UNITED STATES  
DEPARTMENT OF THE INTERIOR  
BUREAU OF LAND MANAGEMENT

FORM APPROVED  
OMB NO. 1004-0135  
Expires: July 31, 2010**SUNDRY NOTICES AND REPORTS ON WELLS**  
*Do not use this form for proposals to drill or to re-enter an abandoned well. Use form 3160-3 (APD) for such proposals.*5. Lease Serial No.  
NMNM12559

OXY USA Inc.- Proposed  
Federal 11 #1  
API No. 30-015-24100

**Permanent Abandonment of Federal Wells**  
**Conditions of Approval**

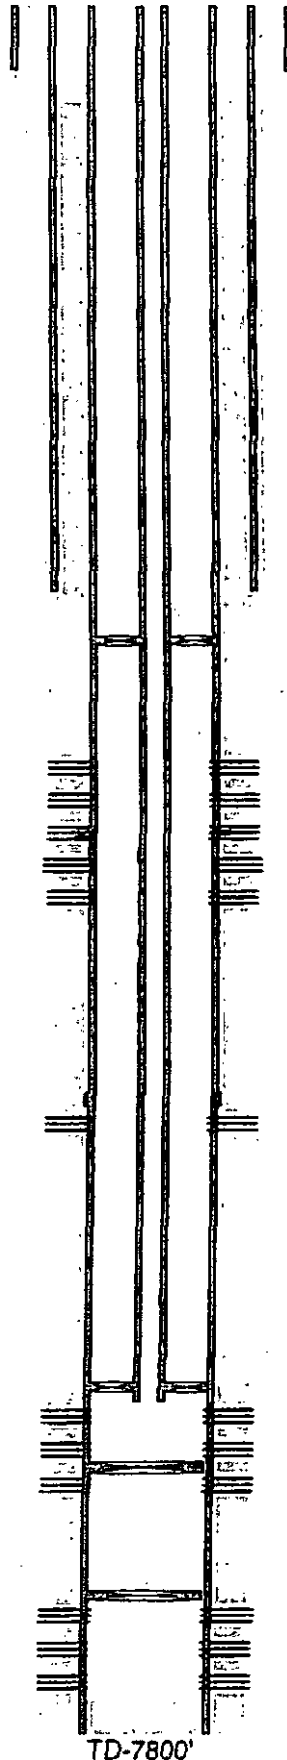
1. RIH & set CIBP @ 6430', M&P 25sx cmt to 6265'
2. M&P 25sx cmt @ 5144-4993' WOC-Tag
3. M&P 75sx cmt @ 4108-3569' WOC-Tag
4. M&P 40sx cmt @ 2730-2450' WOC-Tag
5. M&P 25sx cmt @ 1100-950' WOC-Tag

\*\* BLM REVISED \*\* BLM REVISED \*\* BLM REVISED \*\* BLM REVISED \*\* BLM REVISED \*\*

6. Perf @ 302' sqz 95sx cmt to surface  
10# MLF between plugs  
Above ground steel tanks will be utilized
